ADDENDUM No. 1
BURROUGHS, EATON AND ROWELL ELEMENTARY SCHOOL
ENERGY MANAGEMENT SYSTEM REPLACEMENT
Bid No. 21-47

ADDENDUM NO. 1

**FRESNO UNIFIED SCHOOL DISTRICT
EATON, ROWELL, BURROUGHS ELEMENTARY SCHOOL
ENERGY MANGEMENT SYSTEM REPLACEMENT**

APRIL 22, 2021

SHEET:
M3
PROJECT: 20140

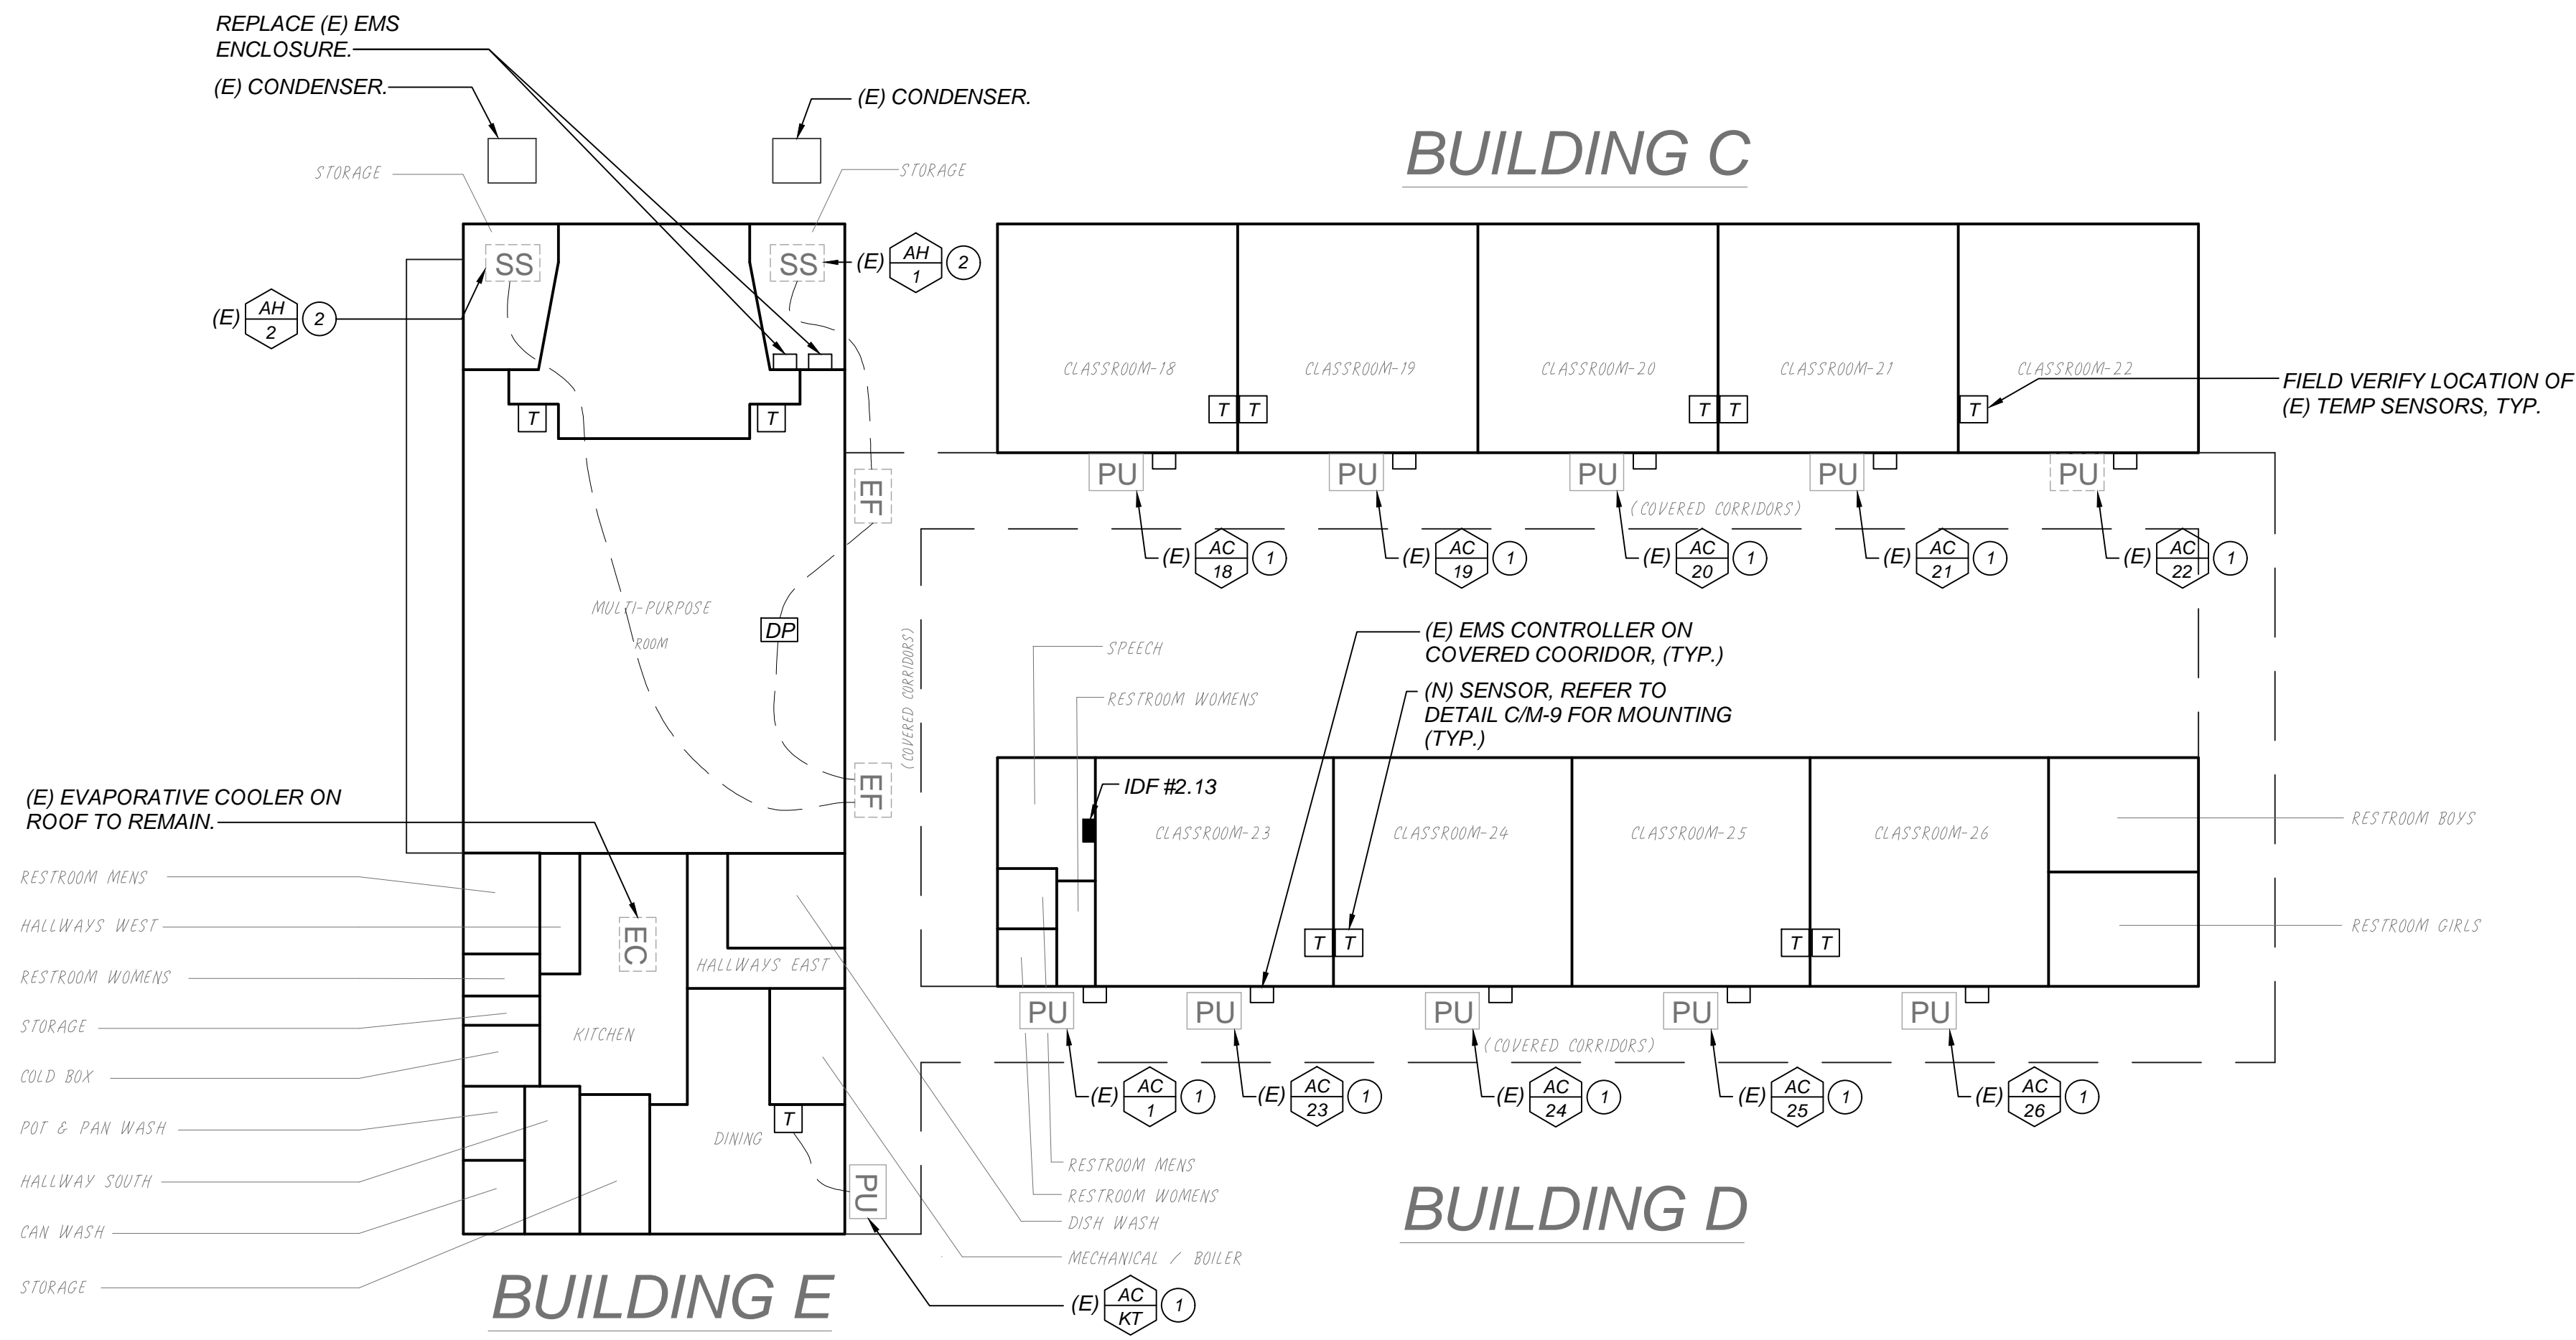
« On sheet M-3 for Burroughs on the MPR kitchen there is an evap cooler unit that is to remain. Does this unit need to be controlled by the new EMS? »

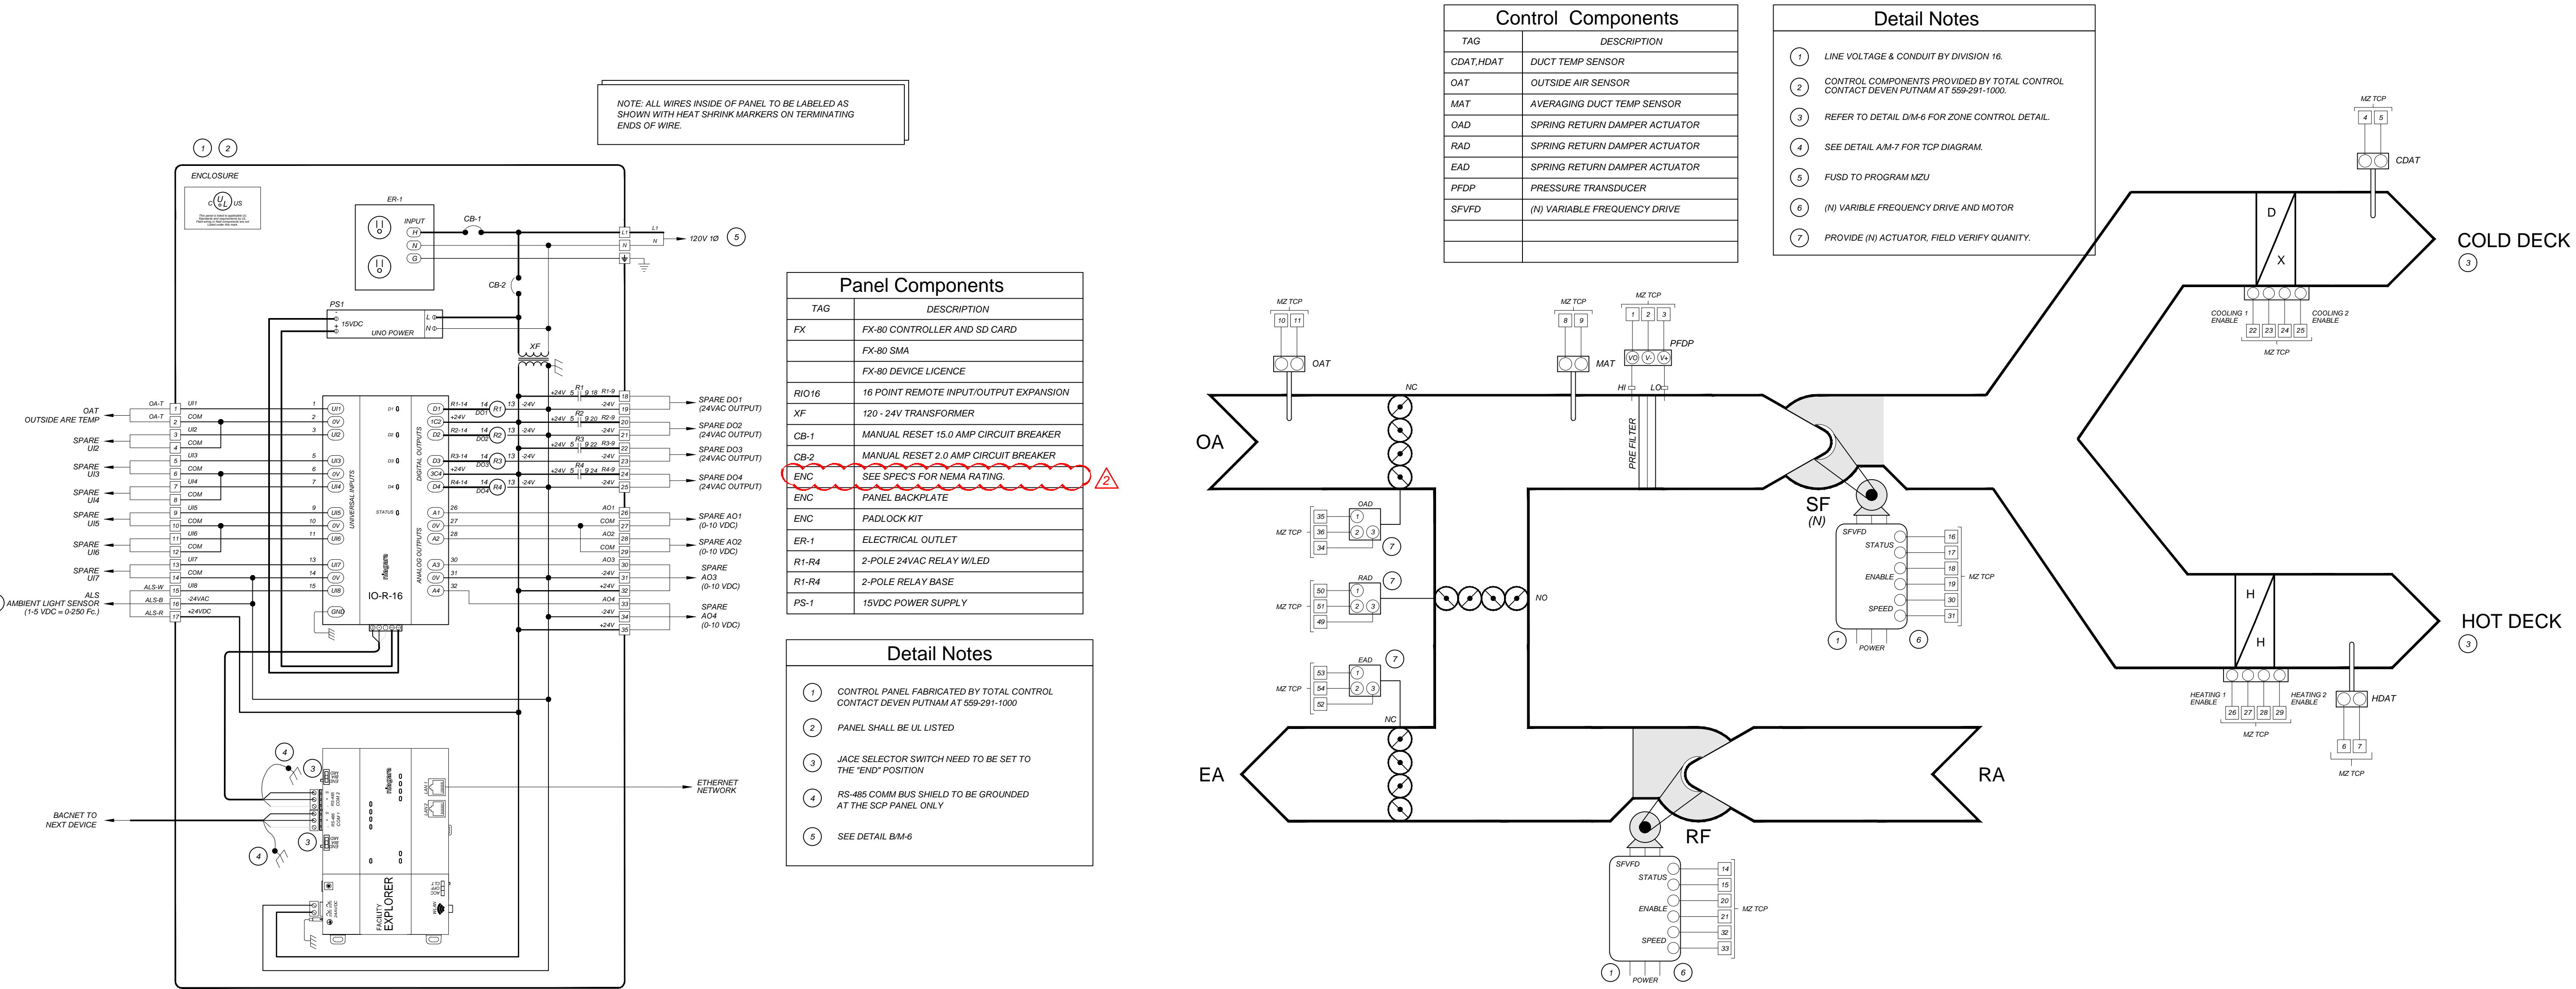
1. On Sheet E-2 (typical), Drawing Key Note 1, should be modified as such:

“DISCONNECT EXISTING FAN MOTORS AND STARTERS IN AC UNIT. REMOVE EXISTING FVNR MOTOR STARTER. INSTALL AND CONNECT NEW VFDS AS REQUIRED WITH ALL NEW WIRING AND PROVIDE FUSING AS REQUIRED BY VFD MANUFACTURER. CONNECT NEW MOTOR. SEE MECHANICAL DRAWINGS AND COORDINATE WITH MECHANICAL CONTRACTOR. REPLACE ANY EXISTING LIQUID-TITE FLEXIBLE CONDUIT WITH NEW (MAXIMUM LENGTH OF 36" PER DISTRICT STANDARD). CONTRACTOR IS TO VISIT THE JOBSITE AND OBSERVE THE EXISTING CONDITIONS.”

2. Note to contractor: The motors will not be changing in size. The “Motor Replacement Schedule” and “Unit MCA Requirements” charts as shown on Sheet E-2 are not needed.
